**GROUND WATER QUALITY BUREAU (GWQB)
DISCHARGE PERMIT
NEW COPPER MINE FACILITY
Issued under 20.6.2 and 20.6.7 NMAC**

Mine Facility Name: Copper Flat Mine
GWQB Discharge Permit Number: DP-1840
GWQB TEMPO AI Number: 1535

Permitting Action: New
Effective Date: XXXX XX, 2018
Expiration Date: XXXX XX, 2018

Figure 2 – Ground and Surface Water Sampling Locations

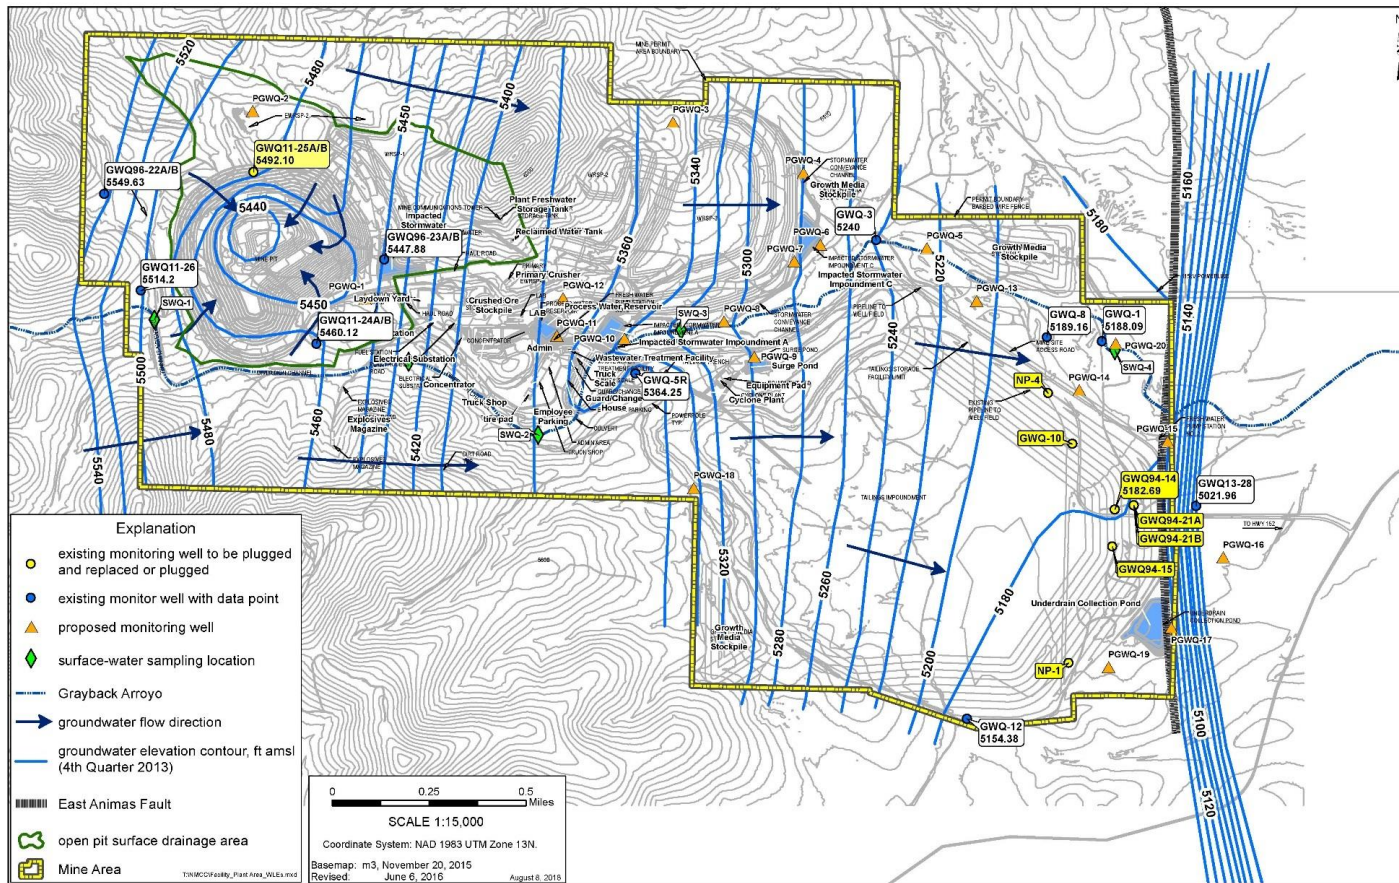
Commented [BR35]: Figure 2 has been updated to provide more clarity on the ground and surface water sampling locations.
